Submissions received on Wainoni road crossing

May 06, 2026 - May 24, 2026

Wainoni Road Crossing for City to Sea Pathway

Submission from Spokes Canterbury

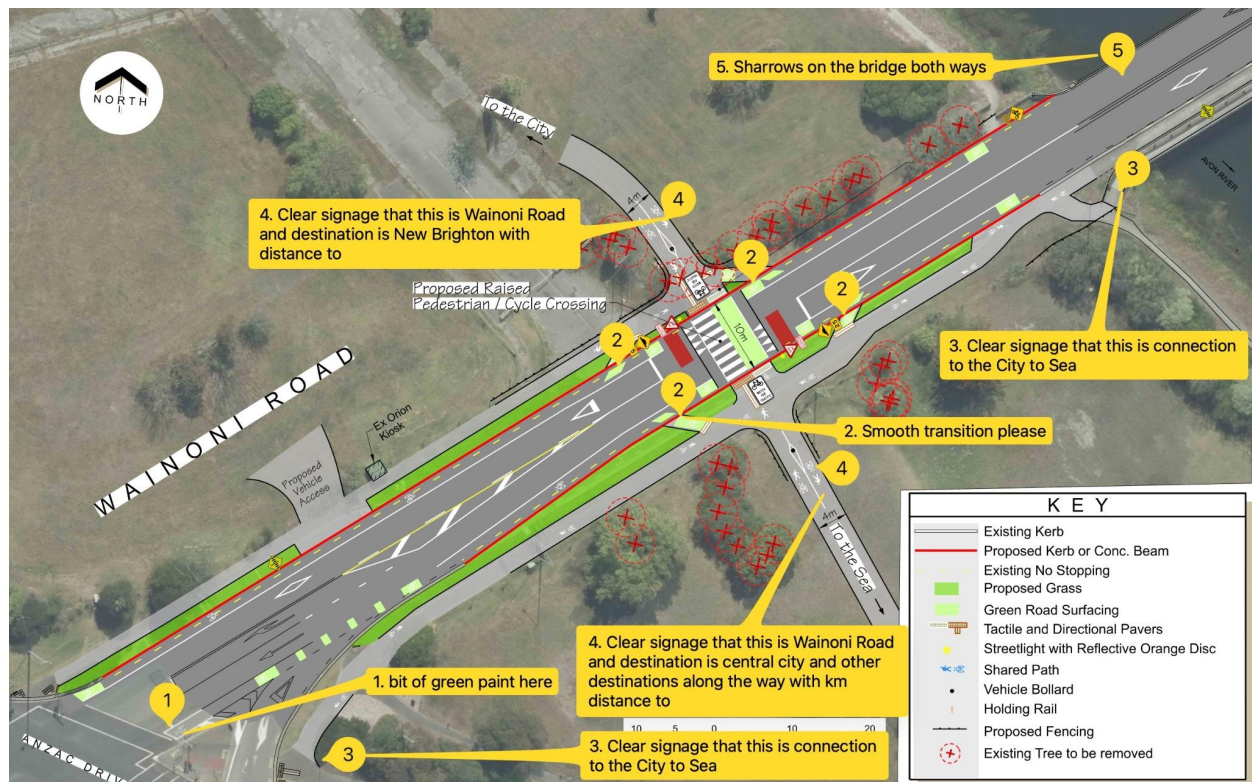
Wainoni Road has higher traffic volumes and the gentle curve of the roundabout exit from New Brighton Road does not slow vehicles down. Vehicles then accelerate to get over the crest of the bridge and are traveling at maximum speed by the time they get to the end of the bridge just

where the current refuge is located. This makes the current crossing point dangerous for cyclists and pedestrians. Raising the level of the road will help with sight lines.

- The plan removes the current refuge between 2 and 3 on the diagram and directs pedestrians and cyclists to the new crossing. People will still want to use the existing path. Provide a shingle path between to get back to the stop bank path. Raising the road 1.5m will probably block people from crossing the road at the existing refuge. It is unclear from the proposal when the old stop banks will be dismantled.
- Additional calming at the roundabout to slow traffic turning onto Wainoni Road, perhaps one of the shallow speed bumps that discourage acceleration.
- Please ensure that the transitions from road to shared path and back are smooth
- At the Anzac drive traffic lights, green paint has been added to the north side, please add some for the south side on the other side of the intersection.
- Signage that indicates this is Wainoni road for users of the shared path.
